5711849

APPLICANTS DANIEL L. FLAMM, WALNUT CREEK, CA; JOHN P. VERBONCOEUR, HAYWARD, CA.

TITLE PROCESS OPTIMIZATION IN GAS PHASE DRY ETCHING

FIG. 1
Cancelled

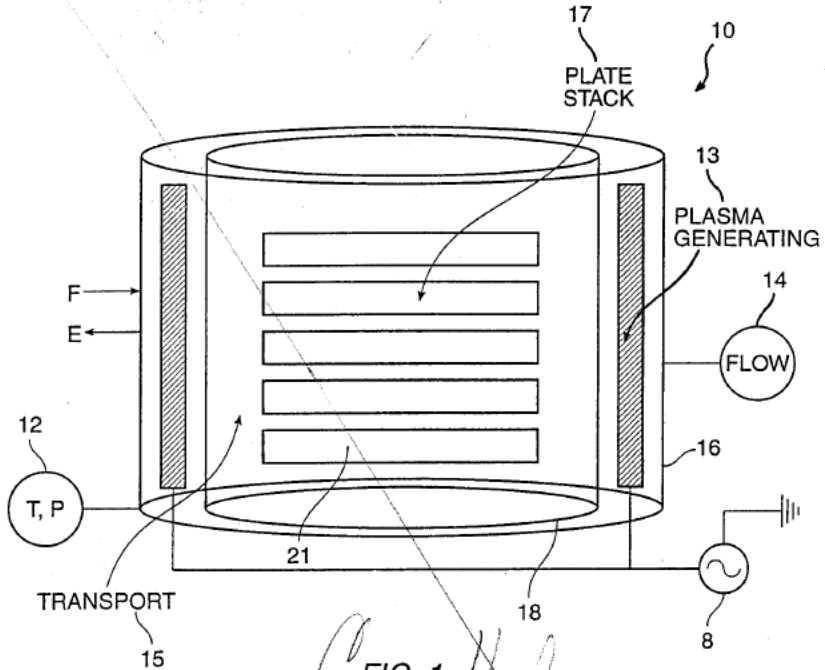
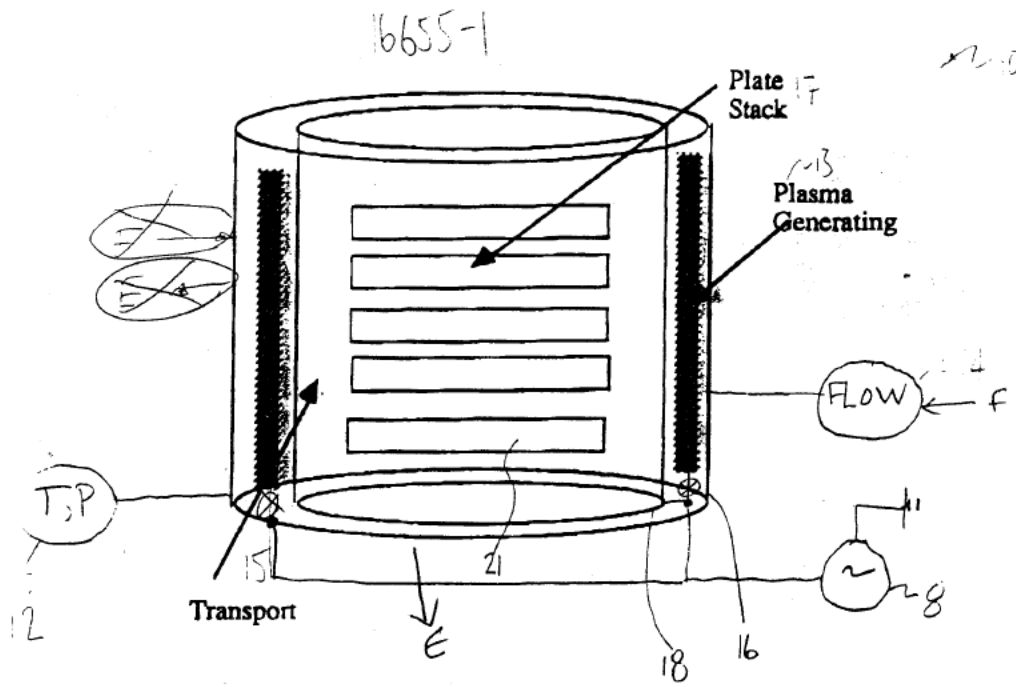
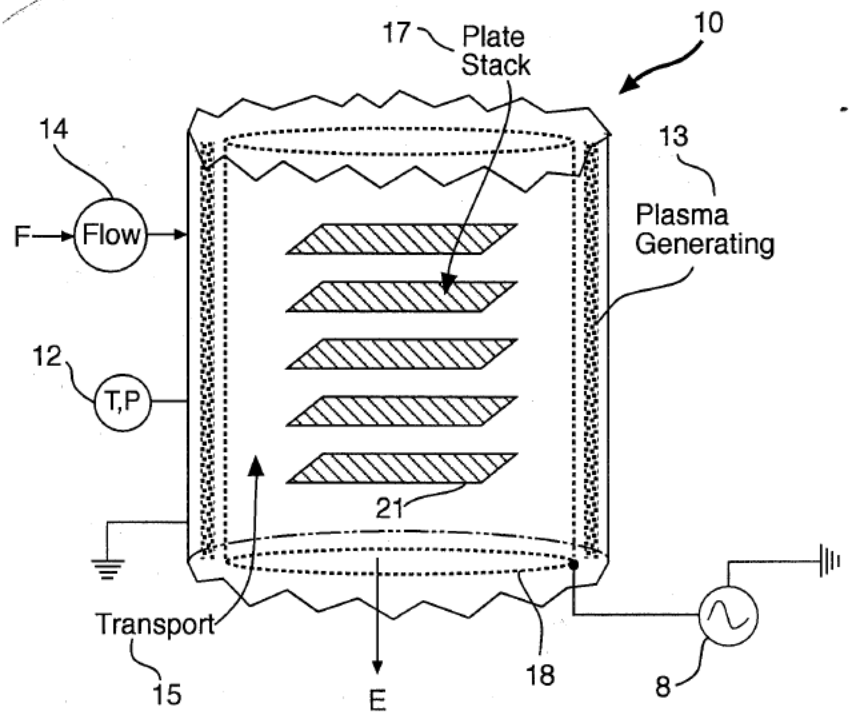
In Fig. 1, chemical flow source 14 was detached from the chemical feed F . In the new formal drawings chemical feed F is shown passing through the chemical flow source 14. Also, the ground connections have been amended to more clearly show the complete circuit for the rf discharge 8. Furthermore, the arrow indicating the exhaust E is moved to the chamber bottom.

With respect to Fig. 1, in the new formal drawings, chemical feed F is correctly shown passing through the chemical flow source 14. See, e.g., Specification, page 4, lines 15-22. Also, the ground connections now more clearly show the complete circuit for the rf discharge 8. Furthermore, the arrow indicating the exhaust E is moved to the chamber bottom for clarity because no opening is shown on the chamber side.

FIG. 3

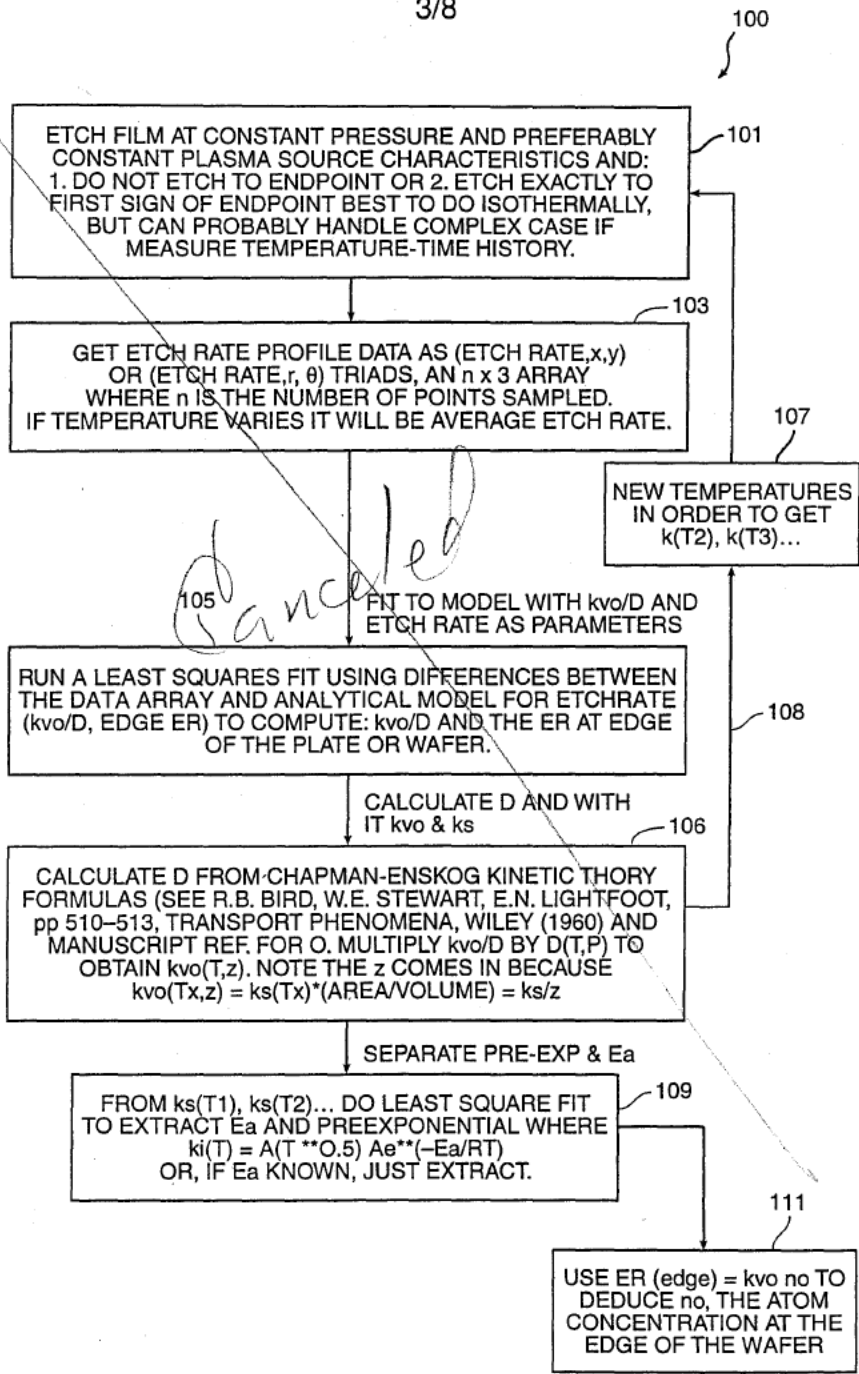
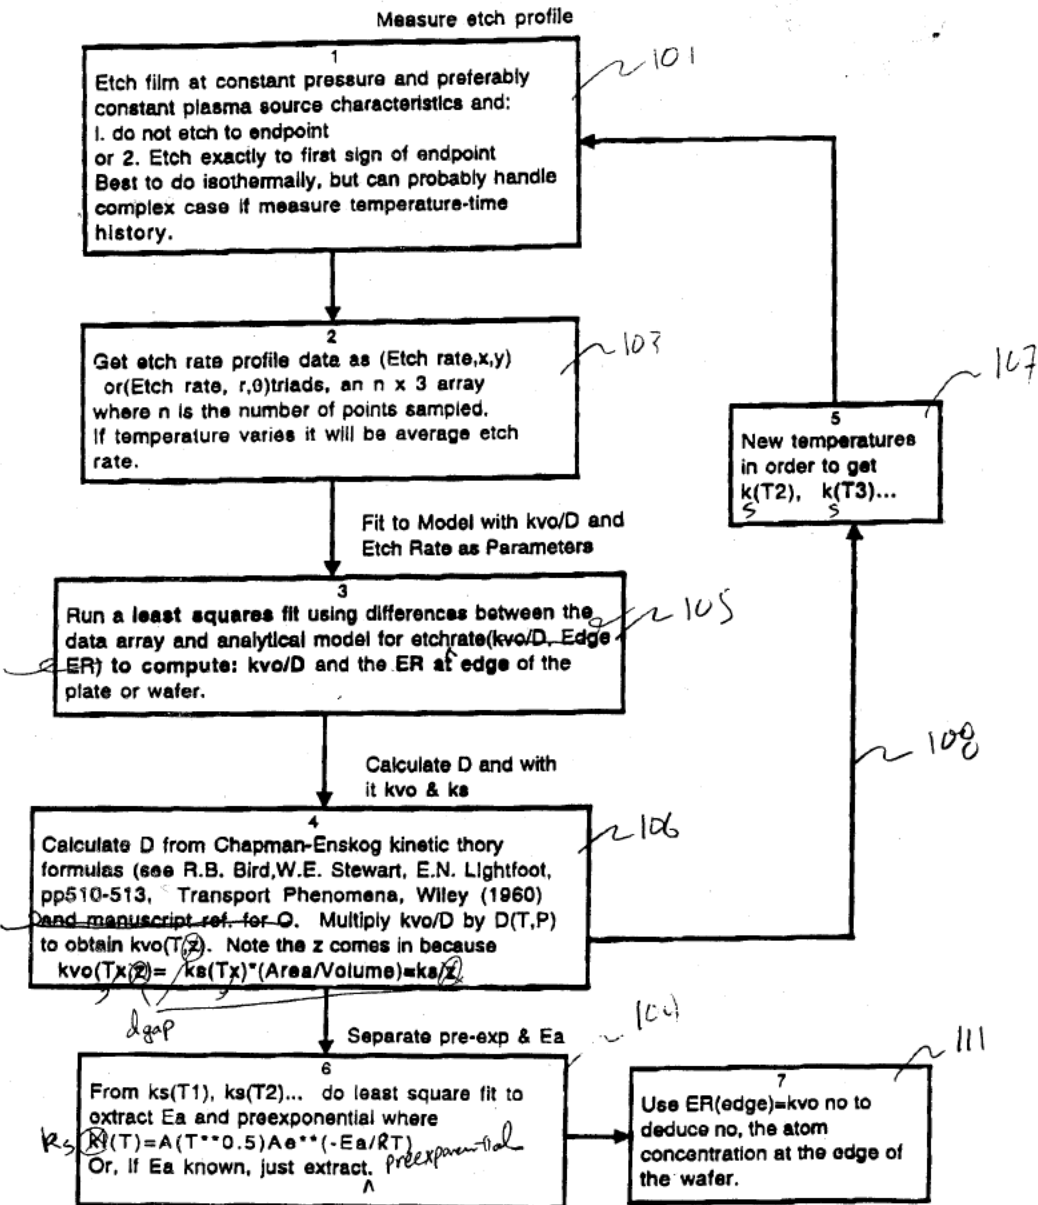
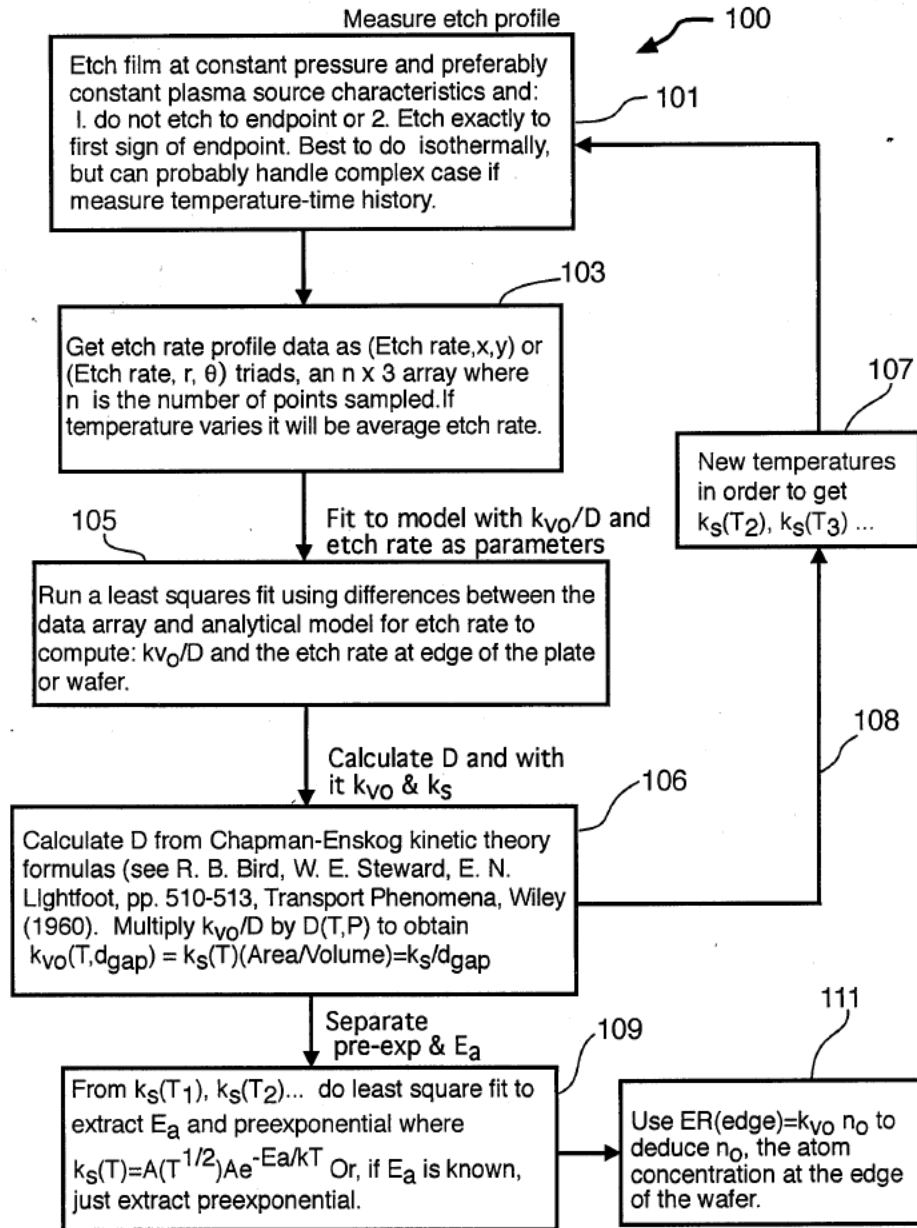
In Fig. 3, as highlighted in red ink, some editorial changes are made in boxes 105, 106, 107, and 109. For example, in box 109 $k_i(T)$ has been replaced with $k_s(T)$. In box 106, "z" has been replaced with " d_{gap} ". Similarly in box 107, "k" has been replaced with " k_s ". In box 109, k_i has been replaced with k_s and "preexponential" has been added at the end.

With respect to Fig. 3, some editorial changes are made in boxes 105, 106, 107, and 109 for consistency with the Specification or to correct some typographical errors. For example, in box 109 $k_f(T)$ is replaced with $k_s(T)$ to maintain consistency with the text. See, e.g., Specification, page 11, the equation after line 15. In box 106, "z" is replaced with " d_{gap} " for consistency with the Specification, for example, at page 11, the equation after line 5. Similarly in box 107, "k" is replaced with " k_s " for consistency with the Specification.

FIG. 4

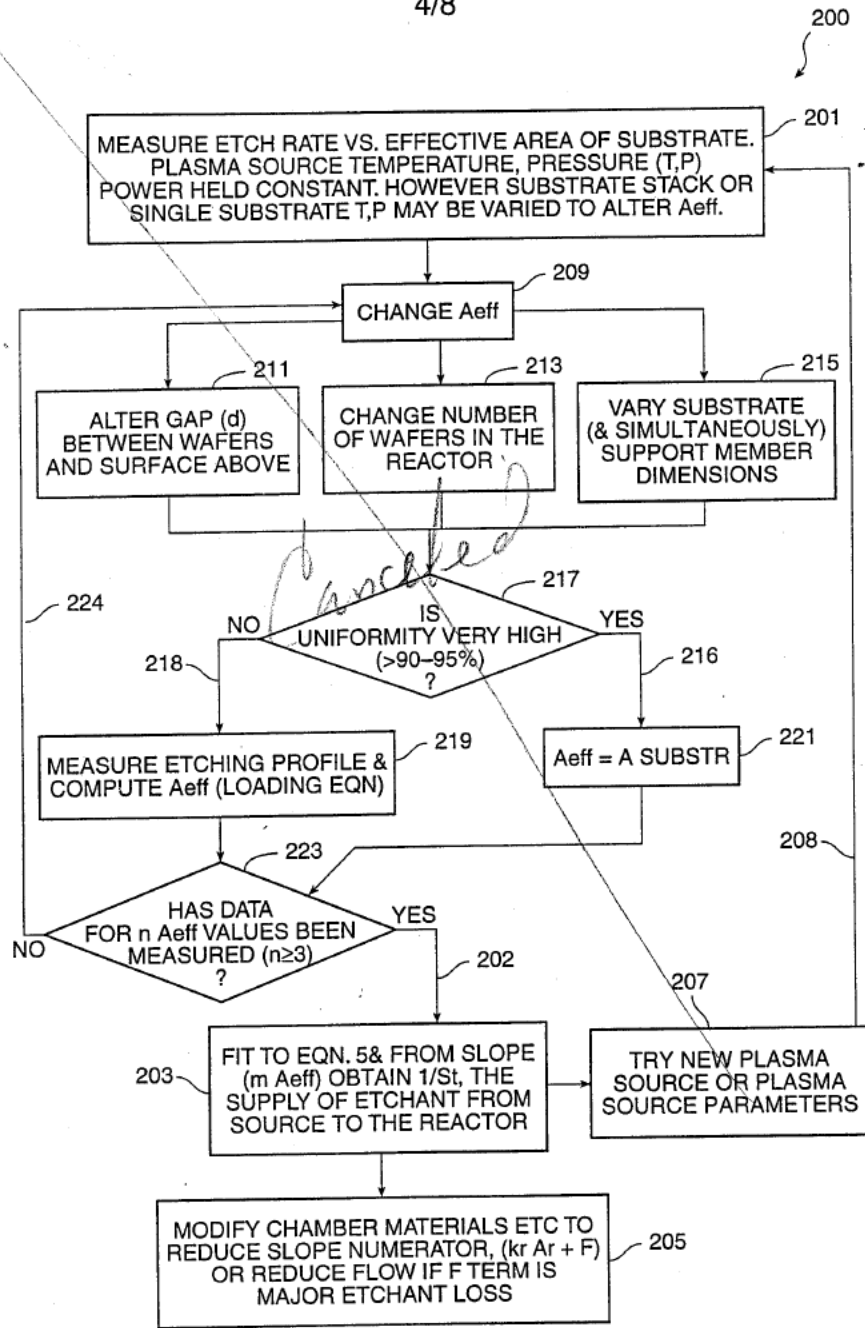
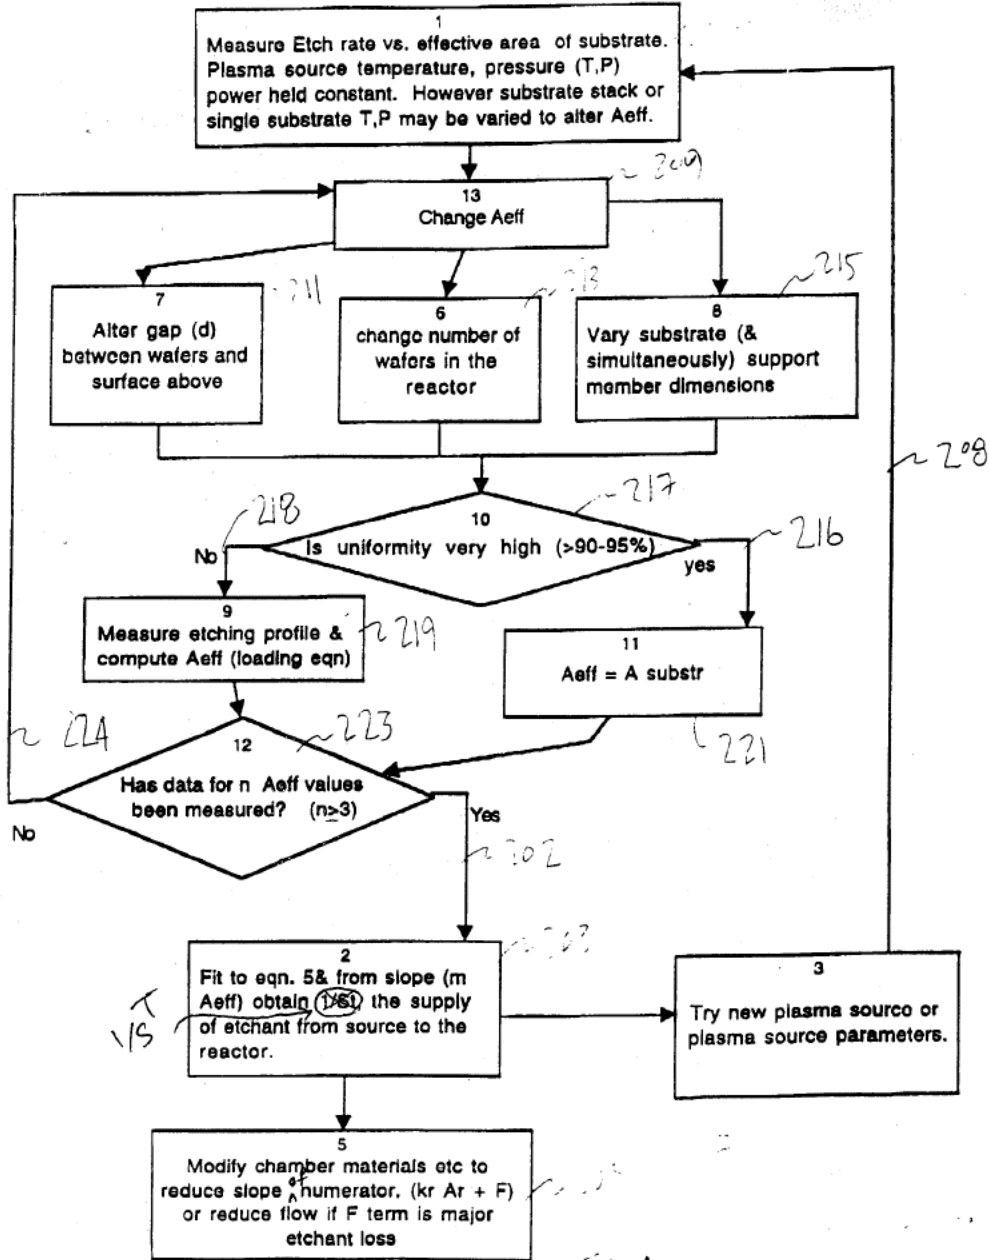
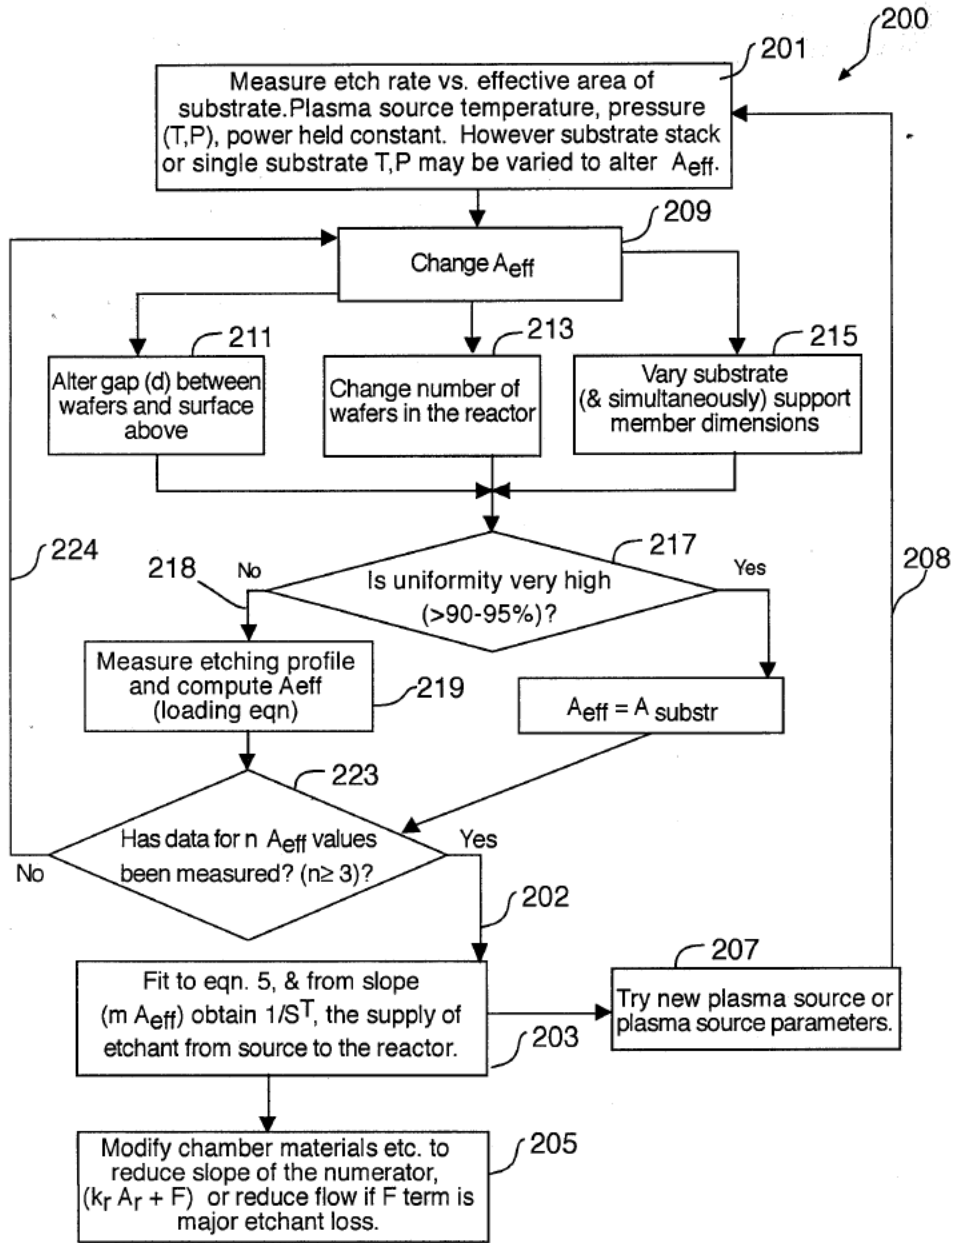
In Fig. 4, some editorial changes are made in boxes 203 and 205. In box 203, "St" is replaced by " S^m ". In box 205, "of" is added after slope.

FIG. 12

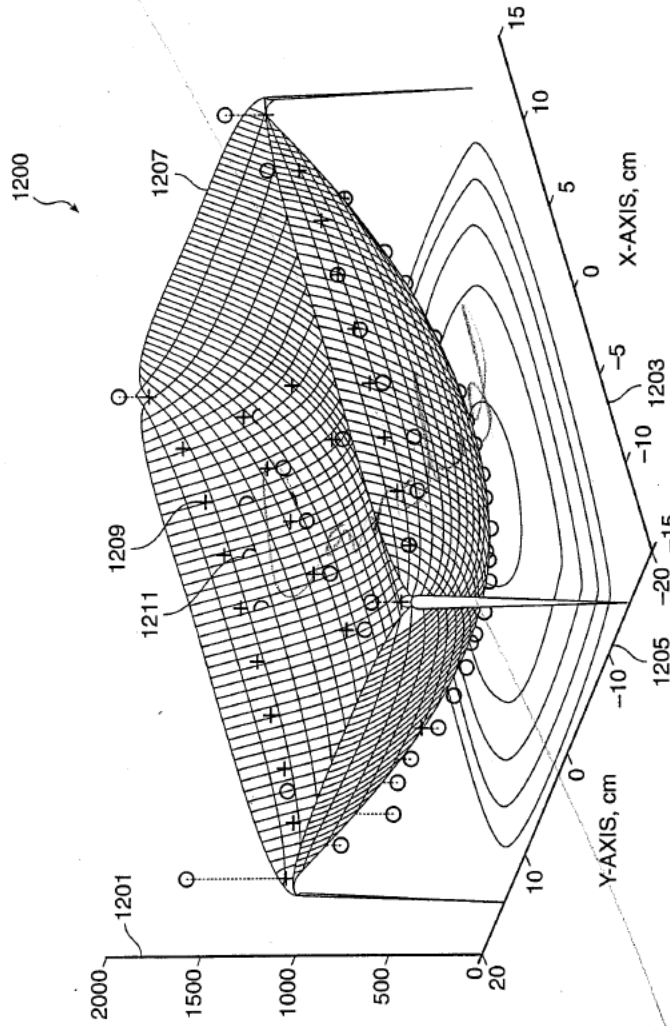
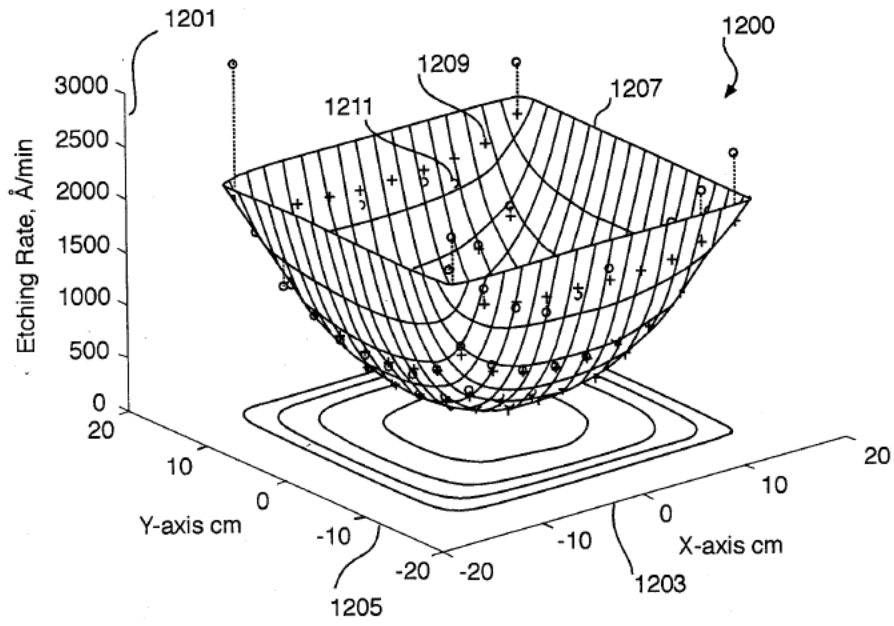
In Fig. 12, the units on the y-axis are changed. Also, the downward spikes at the four corners of the informal drawing are deleted.

In Fig. 12, the units shown on the y -axis of the newly submitted formal drawing are twice as great as the units shown in the original informal drawing. This amendment corrects a typographical error made when making the original drawing. While Applicant believes that those skilled in the art would understand the invention and the error in Fig. 12, this correction is made to avoid any possible confusion on the part of the reader. Also, the downward spikes at the four corners of the informal drawing are absent in the formal drawing. These spikes were the result of utilizing a limited number of mathematical terms to generate the plotted surface. The gridded pattern shown in the formal drawing has no spikes, for example, in accordance with the complete equation in the Specification at page 24, after line 10, and the text at page 26, lines 1-4.

FIG. 7

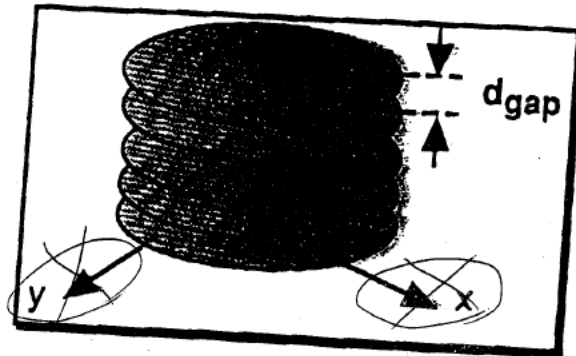
In Fig. 7, the two Cartesian axes at the bottom of the informal drawing are deleted.

With respect to Fig. 7, the two Cartesian axes at the bottom of the informal drawing are deleted because they are not referenced or used in the radial coordinate system of this figure.
